Comment Set E4, cont.
 Southern California Edison Company

SCE COMMENTS ON DPV2 DEIR/DEIS
 DEVERS HELIPAD RELOCATION, AUGUST 2006

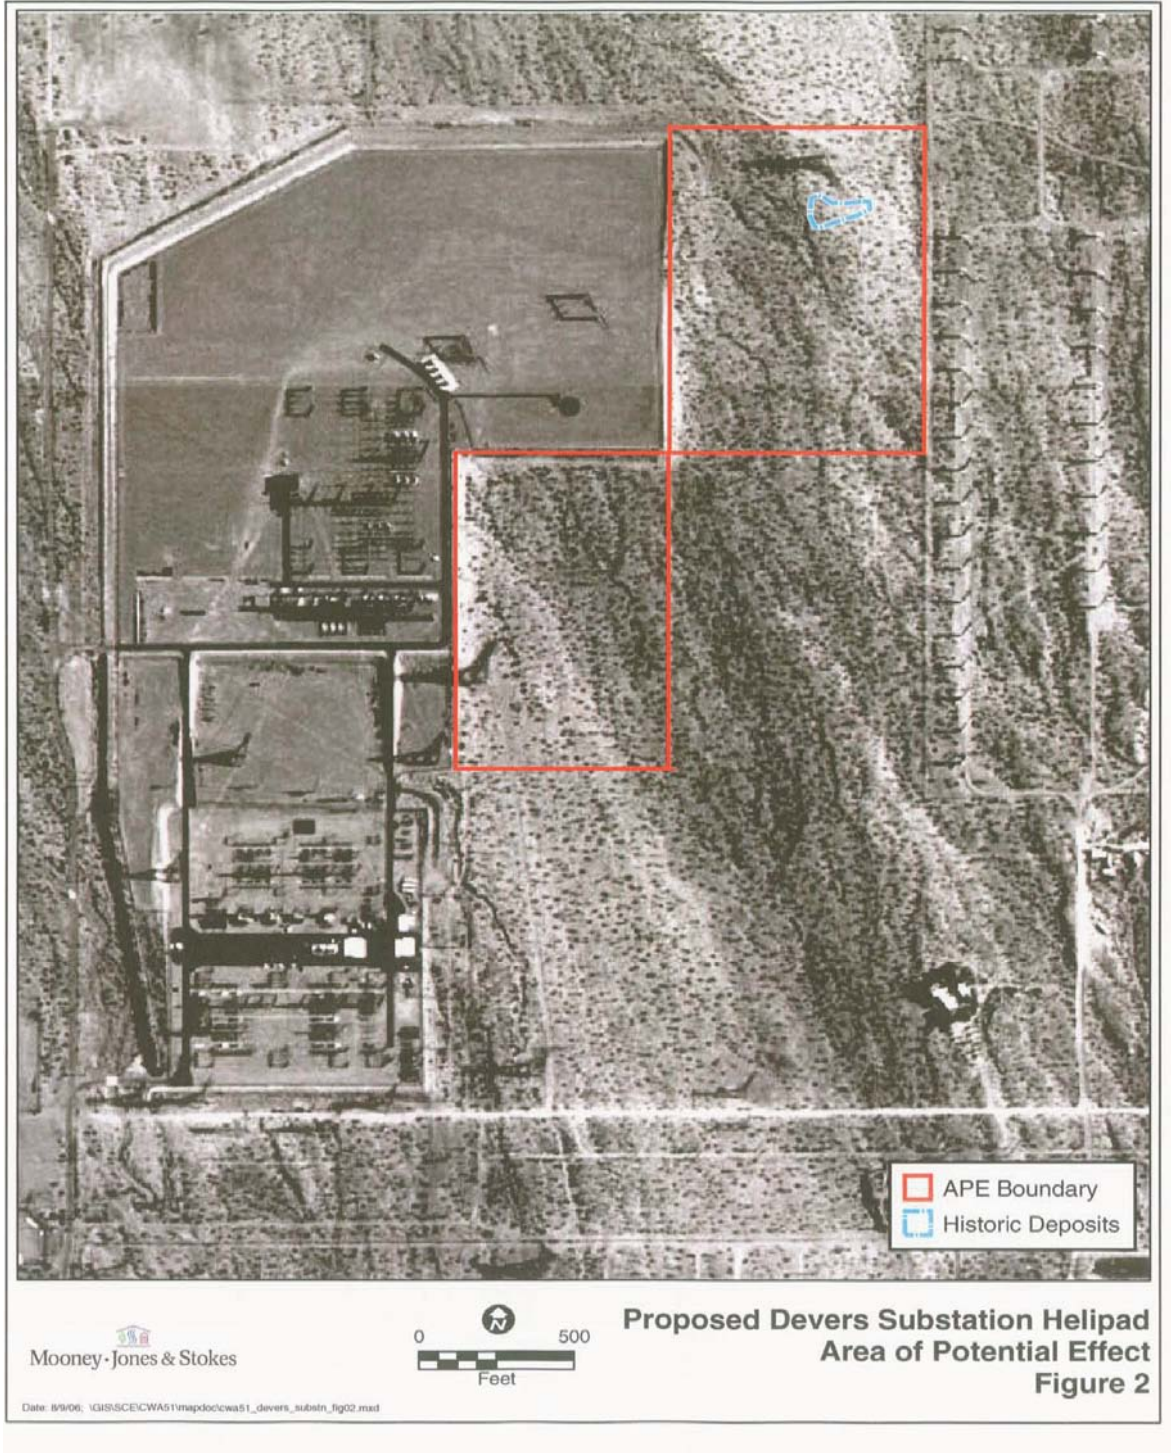
Results of survey reveal a cluster of five historic refuse deposits in the northeastern most quadrant of the study area (Figure 2). These deposits are each small (0.5 to 1.5m diameter), discrete deposits of fragmented sanitary cans, ceramics, and glass; among them one deposit with sun colored amethyst glass fragments. No additional cultural resource sites are present within the project boundaries.

Because of the new resource discoveries in the northeastern most portion of the project area, further effort is warranted to properly record and report this new resource finding. In terms of the proposed construction, it is recommended that this portion of the project area be removed from consideration for location of the helipad and service road. Until proper recording and site evaluation are conducted, it is further recommended that SCE avoid impacting or disturbing this area of the project site.

E4-8 Information about the results of cultural resources surveys for the proposed helipad have been incorporated in the Cactus City Rest Area to Devers Substation sections (Section D.7.2.7 on page D.7-20 and Section D.7.6.7 on pages D.7-70 to D.7-72). The following new subsection has been added to Section D.7.2.7:

One cultural resource was identified within a 40 acre area being considered for use as a replacement helipad and service road. This cluster of five discrete historical refuse scatters has not been formally recorded or evaluated for NRHP eligibility (Eckhardt, 2006).

Northern-most portions of the survey area with Mojave creosote bush scrub vegetation and sandy wash, facing southwest.

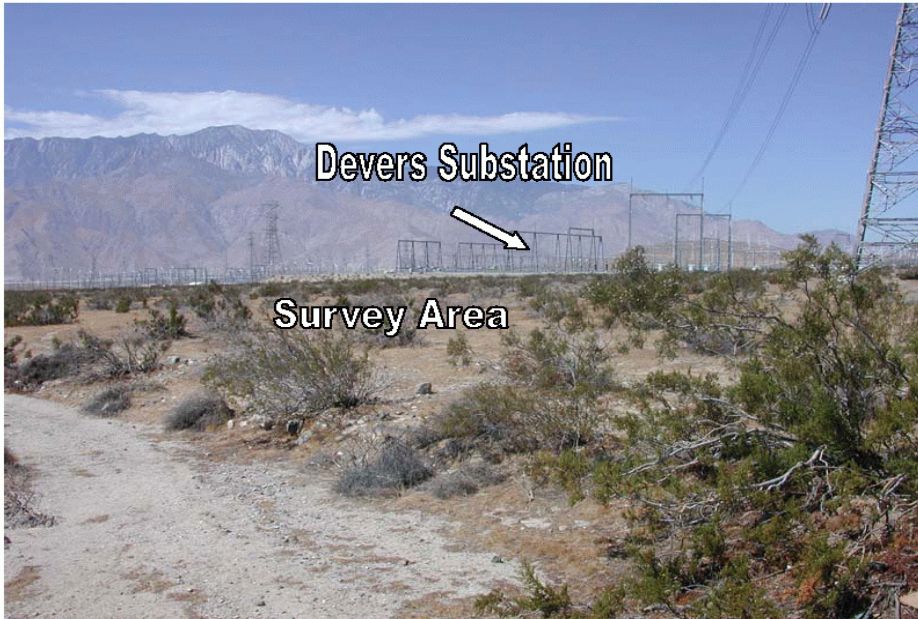
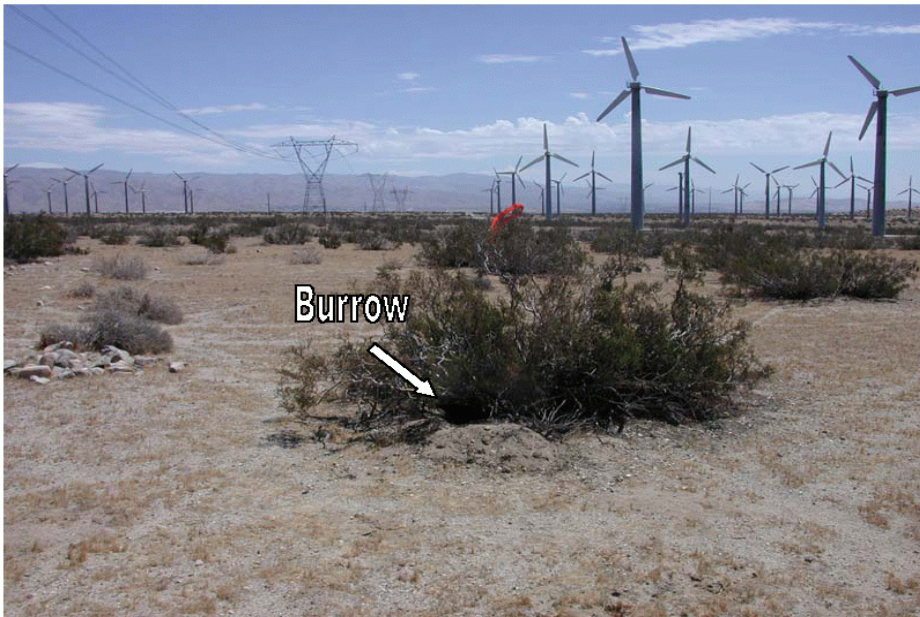
One old and unoccupied burrow (GPS Coordinate: Latitude 33° 56' 30.5"/Longitude 116° 34' 19.4") with the potential for desert tortoise occupation (*Gopherus agassizii*) was observed during the survey. No other desert tortoise sign was observed and the burrow was partially collapsed; however, the location of the burrow (under a creosote bush) and its large size make it suitable for use by a desert tortoise. The burrow was observed in the northern most plot or survey area, approximately 150 feet south of an existing steel lattice tower structure located near the northern boundary of the plot. See photograph at the end of this report.

To avoid or minimize impacts to biological resources as a result of project-related activities within the survey area, it is recommended that focused surveys should be conducted for the following species prior to any ground disturbing activities:

- Desert tortoise.
- Coachella Valley milk-vetch.

E4-9 Sections D.2.2.7 of the Draft EIR/EIS describes the potential occurrence of the Coachella Valley milkvetch (page D.2-66), desert tortoise (page D.2-67), and Coachella Valley fringe-toed lizards (page D.2-67) in the areas adjacent to the Devers Substation. The information provided in the Devers Substation Habitat Assessment – Biological Site Assessment Report (prepared by TRC Essex and dated August 10, 2006) regarding the potential occurrence of these species near the Devers Substation is consistent with the information reported in the Draft EIR/EIS.
